Market Information

1st June 2004

Changement to Fixation of Air Spring 951 812 721 0 Replacement Air Spring 951 811 712 0

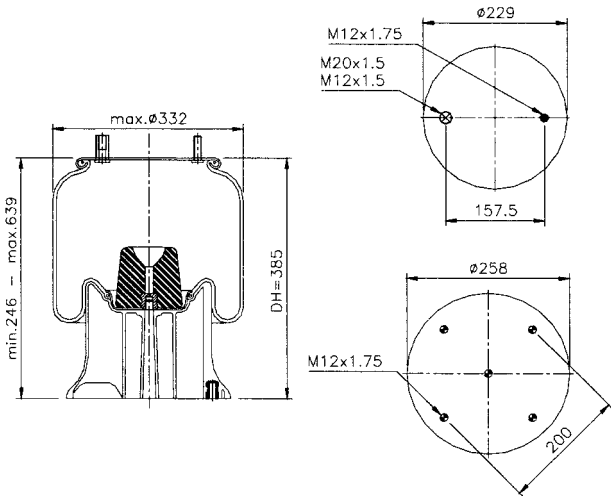
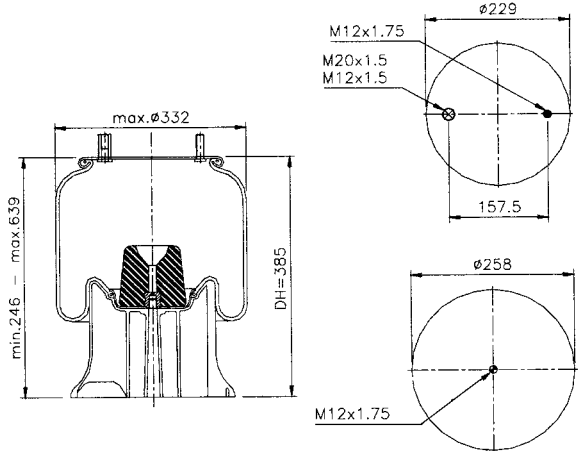
To avoid improper mounting of air spring 951 812 721 0, we changed the fixation threads at the bottom of the piston. Previously, additional to the central female thread, 4 further threads were foreseen for optional usage. Since no vehicle manufacturer used them they have now been taken away.

WABCO	Scheme	OE
<p>Air spring complete 951 812 721 0</p> <p>Bellow 896 130 103 4</p>	<p style="text-align: center;">previous fixation</p>  <p style="text-align: center;">new fixation</p> 	<p>Fruehauf UJB 02358 UJY 0099 Trailor M001774 Samro 25324 Trouillet HT 18002</p>
